Development Review Division

DATE: March 4, 2021

SUBJECT: SP20-081 New Horizon Daycare Site Plan – Planning Review 2

PARKING LOT SITE LAYOUT

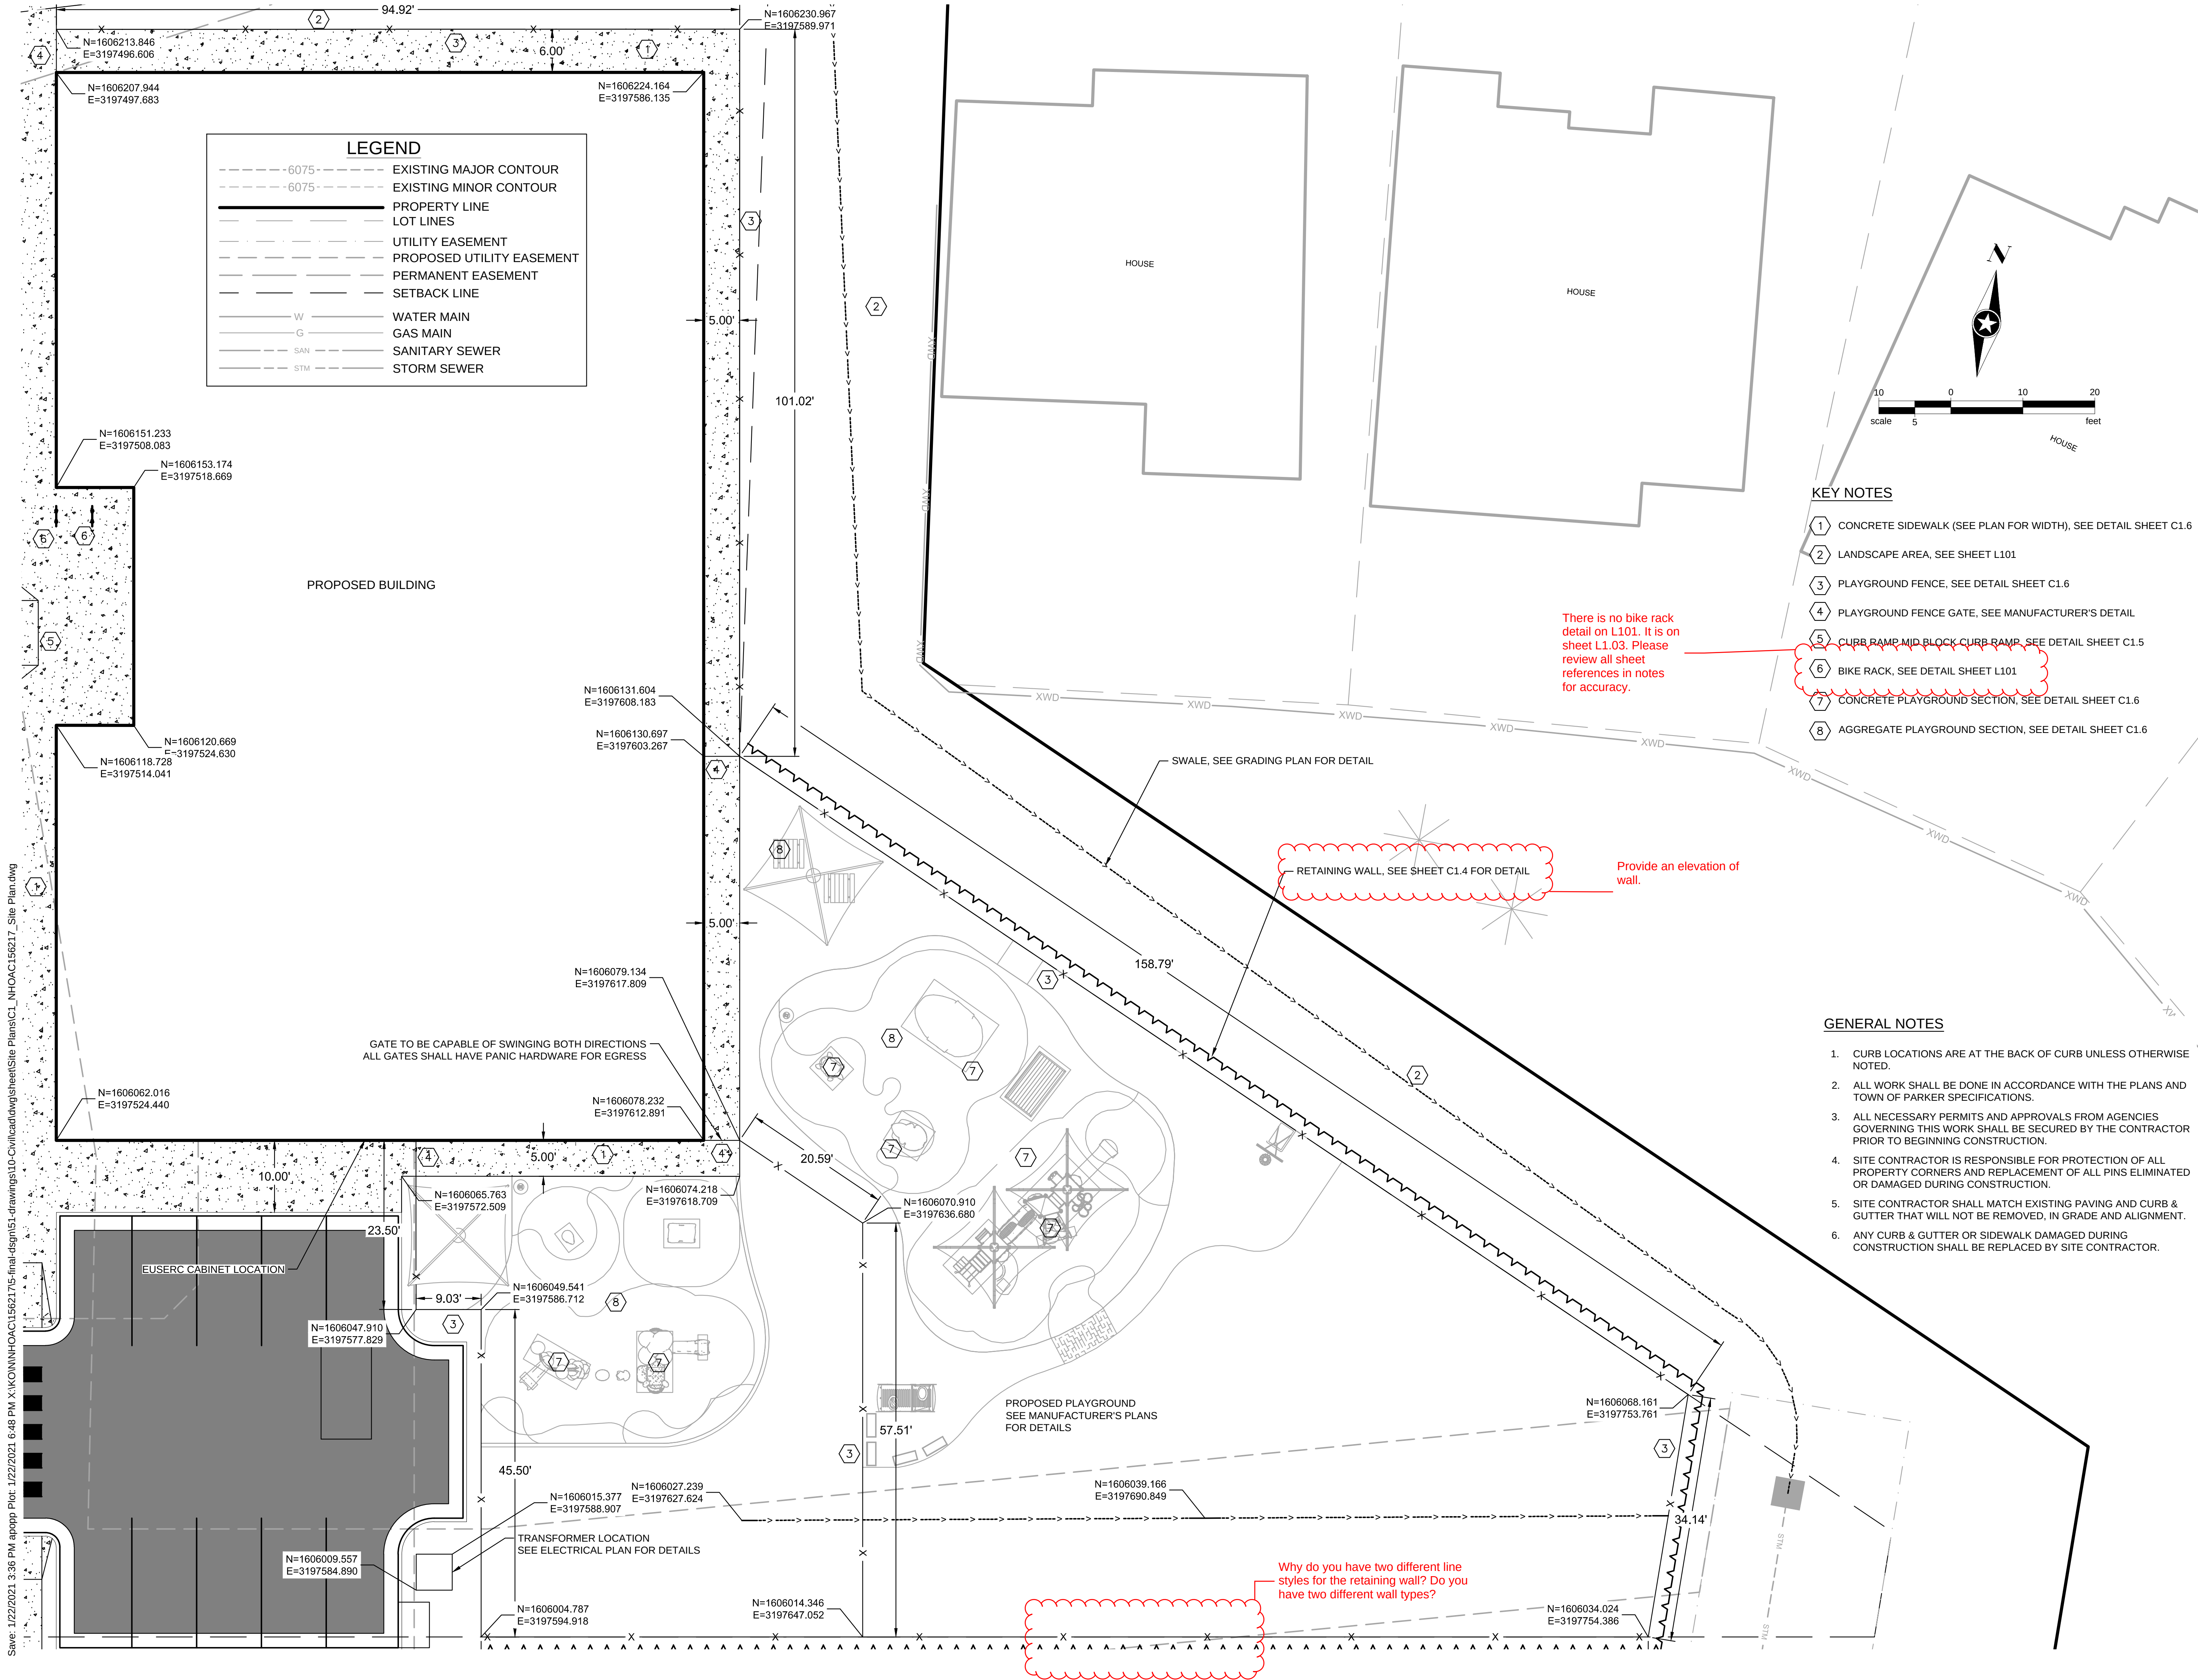
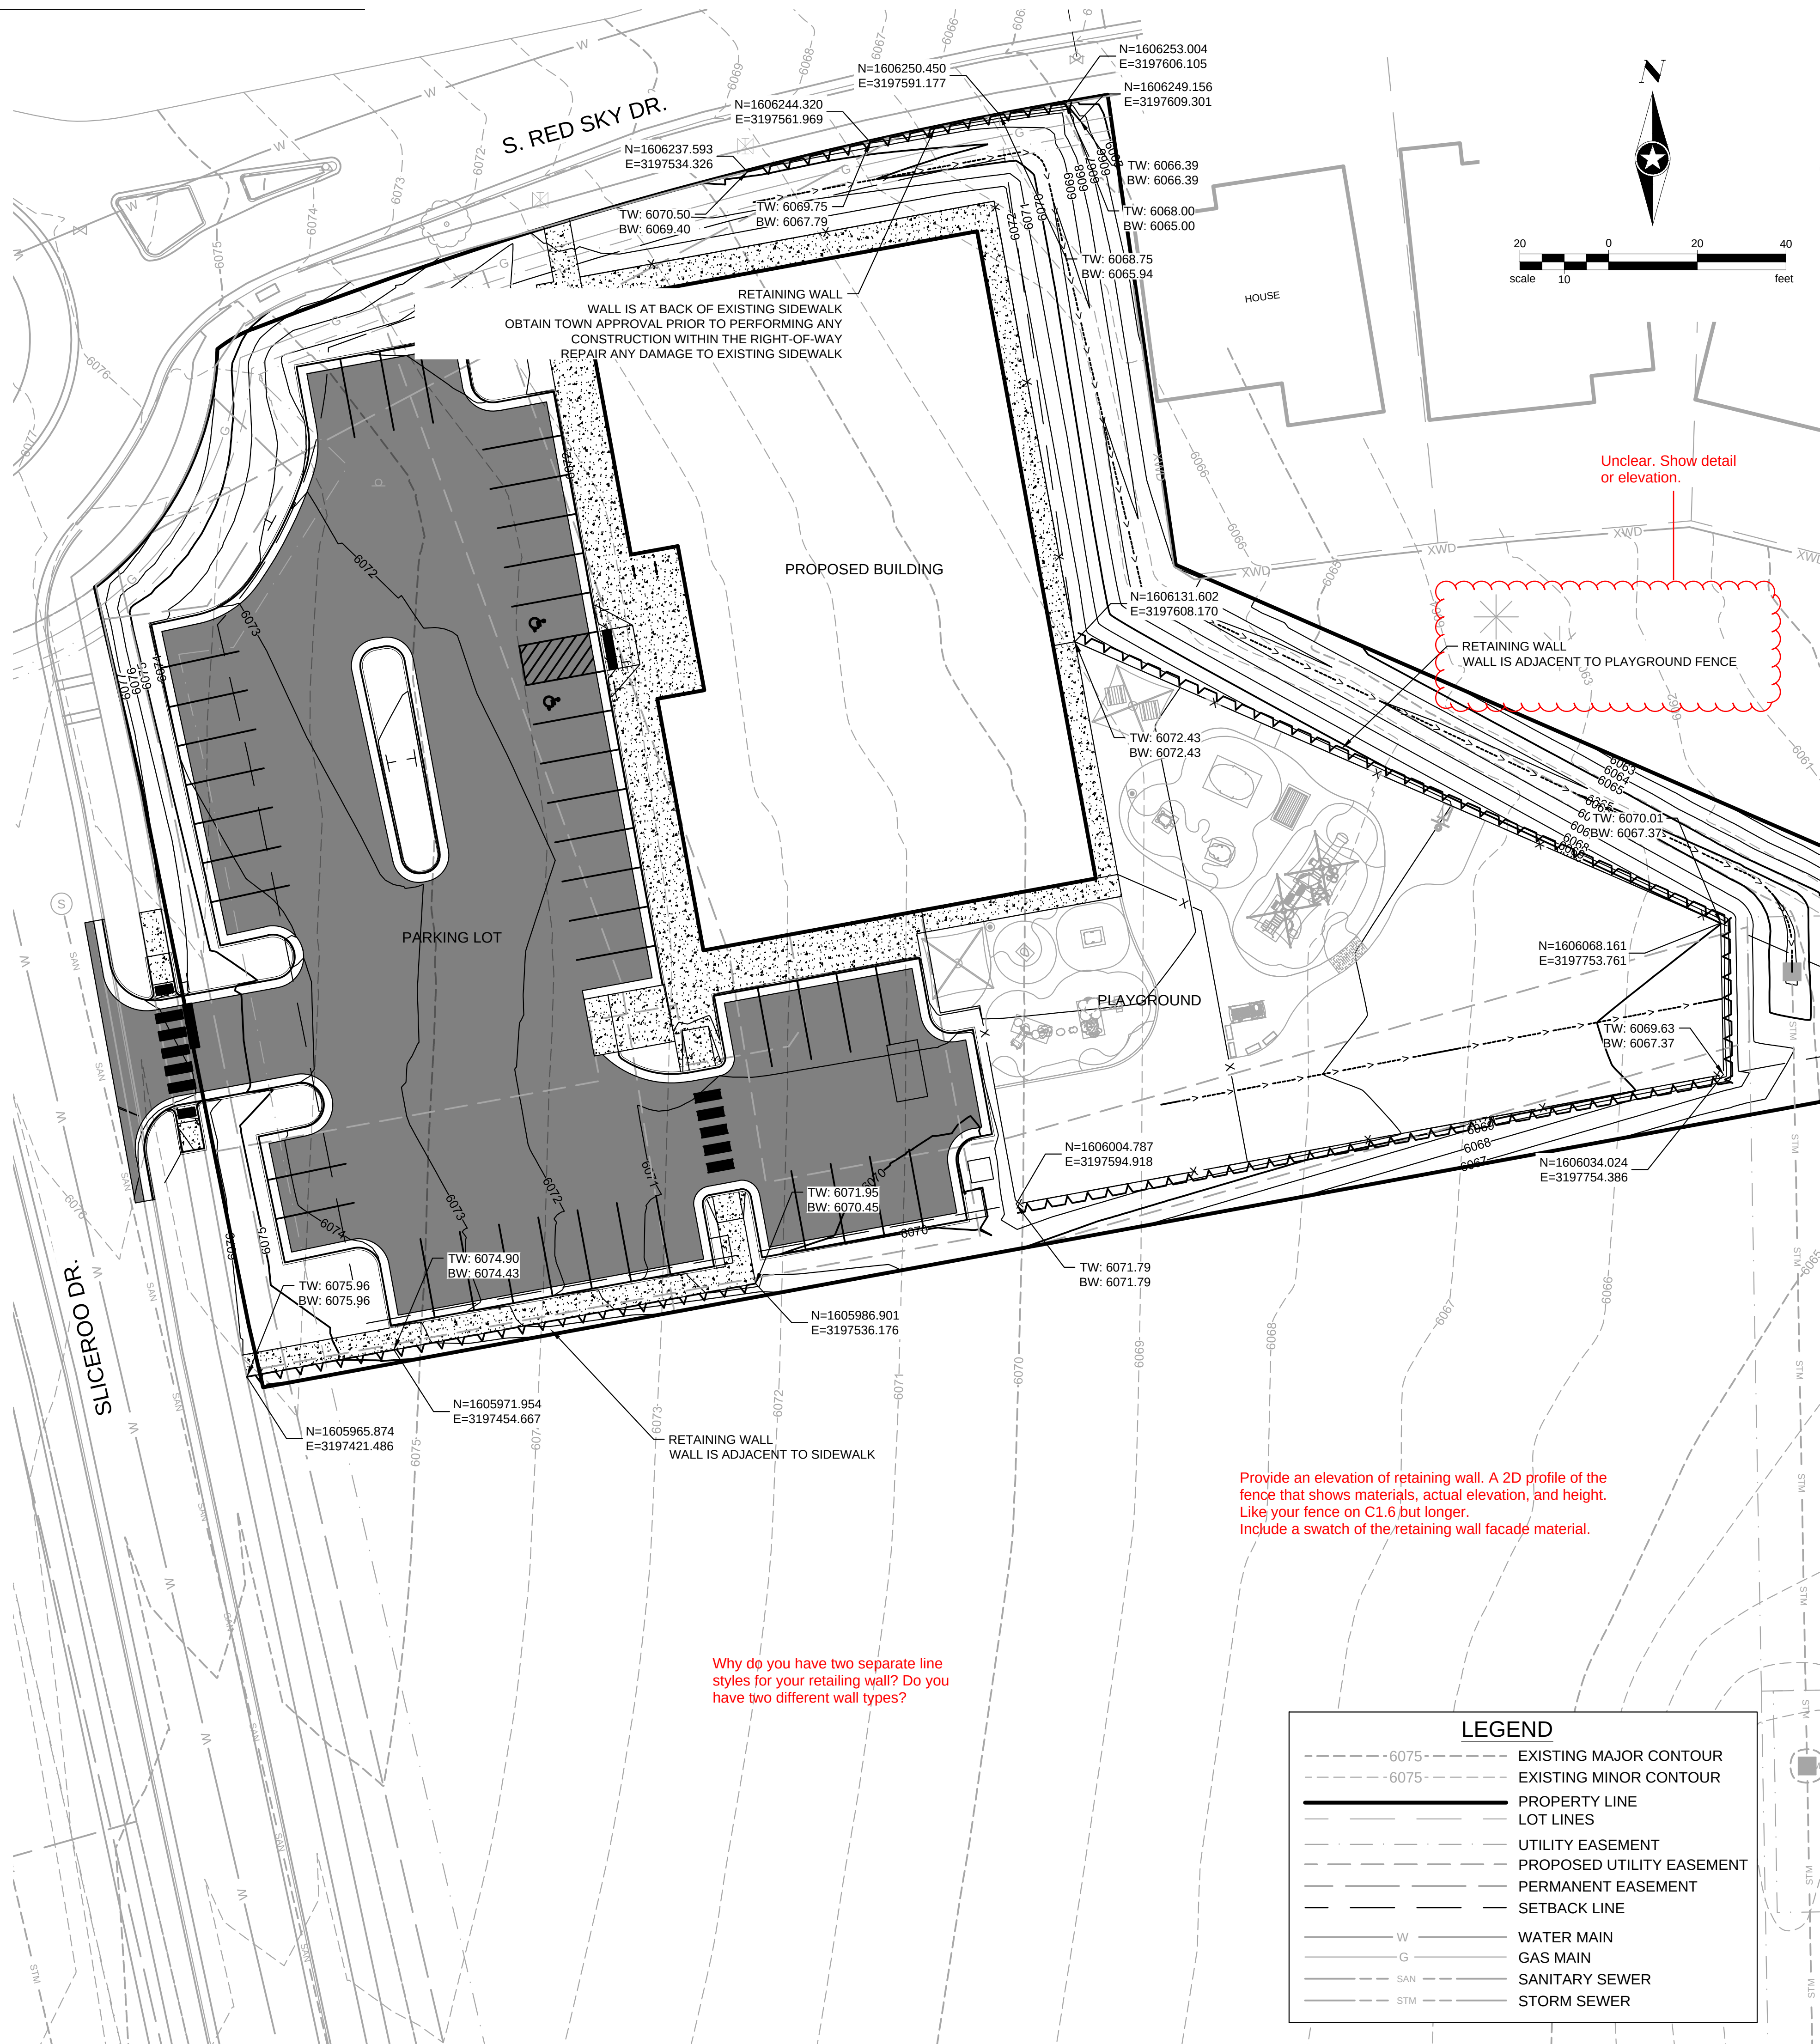
Parking spaces adjacent to landscaping shall be 10 feet in width or a concrete strip, at least eighteen (18) inches wide, shall be provided on the adjacent side of the island for pedestrians to step out of the car. LDO 13.06.050 F.1

Show all dimensions on plan.

Parking that faces into a sidewalk must have stop bars if the sidewalk is less than 8 ft wide.

1 WEST ELEVATION
SCALE: 3/16" = 1'-0"
0' 2' 6' 12' 21'-4"

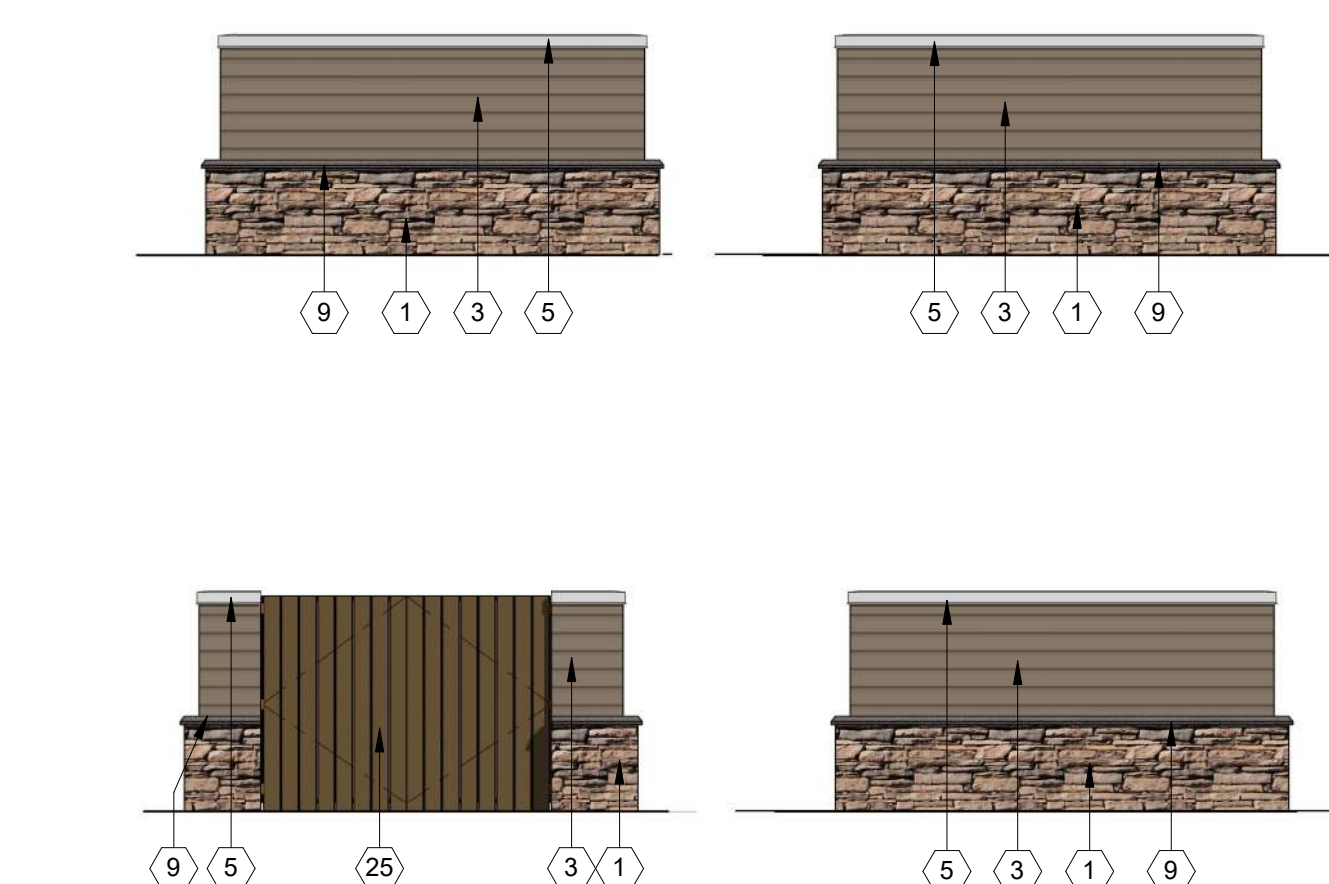
Please label the new PDF sheet of your physical materials board (and include in site plan set) with the number reference here so I can tell what corresponds to what. I am not seeing the limestone that exists on the physical materials board in this list. Was that removed between submittals?

Your building does not meet Standard #3 on page 51 of the DDS - breaking down the building horizontally or vertically. Are you trying to do top/middle/bottom breaks? Or vertical breaks along the facade of the building? Vertical breaks requires that the entire facade face either project or recede. Your roof elements that project 1 foot out do not count. Please read the standards carefully. Call me with any questions.
